Nomination Form Anadromous Waters Catalog

112-50-10050 CORRECTION

Water body name: Wachusett Creek Survey date: 8/29/2022

Figure 1.—Bridge surface at waypoint 1636.

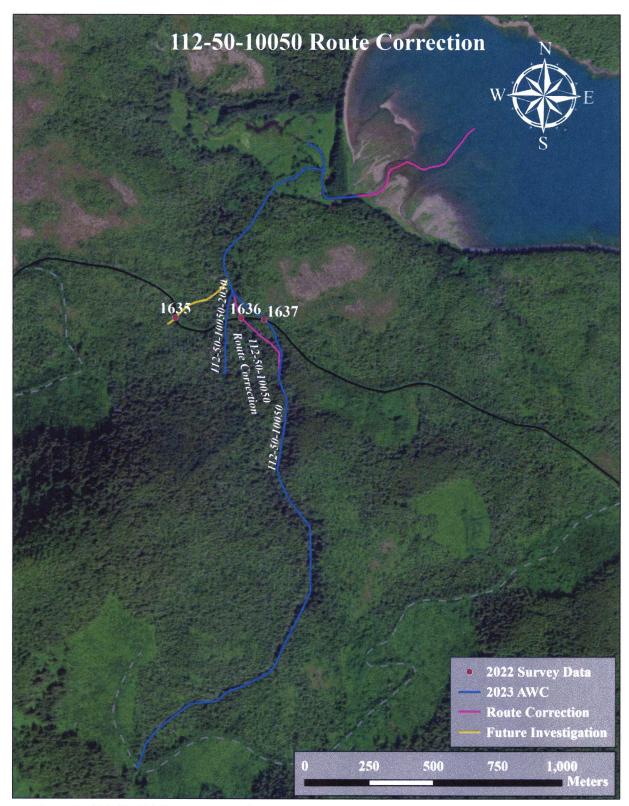
Findings: We surveyed this cataloged stream using and GPS and found that the stream path is incorrectly mapped. The stream flows under a bridge several hundred feet to the west of the existing stream path in the catalog (Table 1; Figures 1, 2).

Figure 3.–112-50-10050 route correction map.

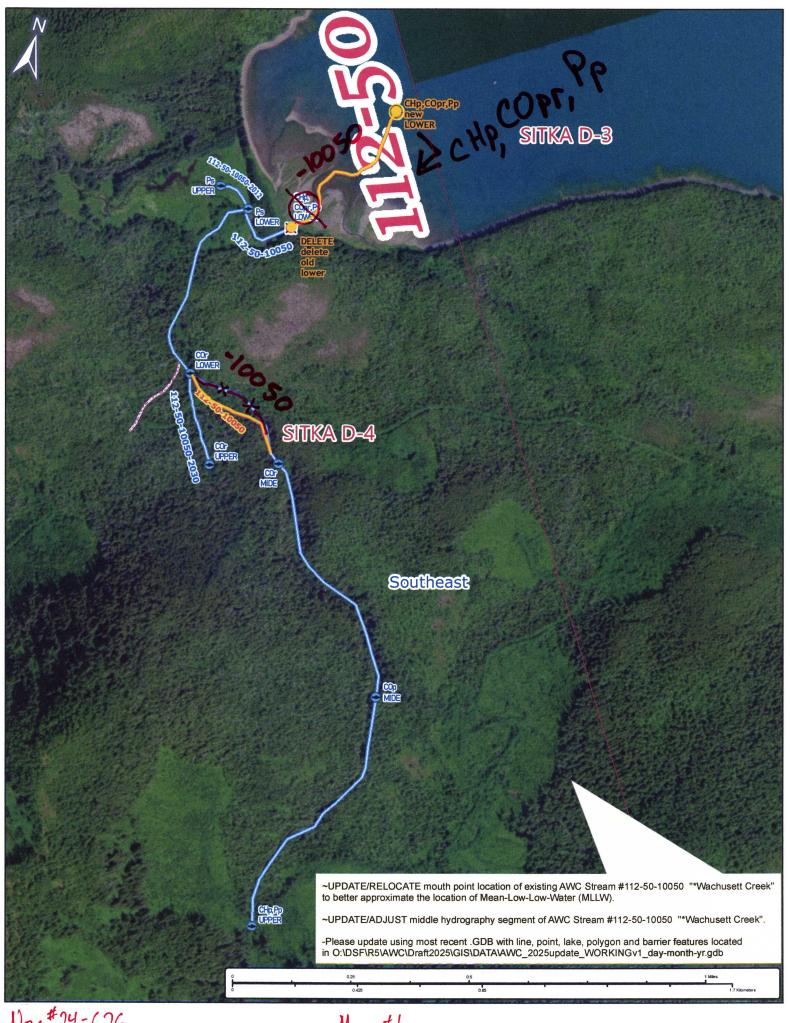
Recommendations: Correct Stream No. 112-50-10050 in the anadromous waters catalog to

reflect the field verified stream path and extend stream into the intertidal (Figure 3).
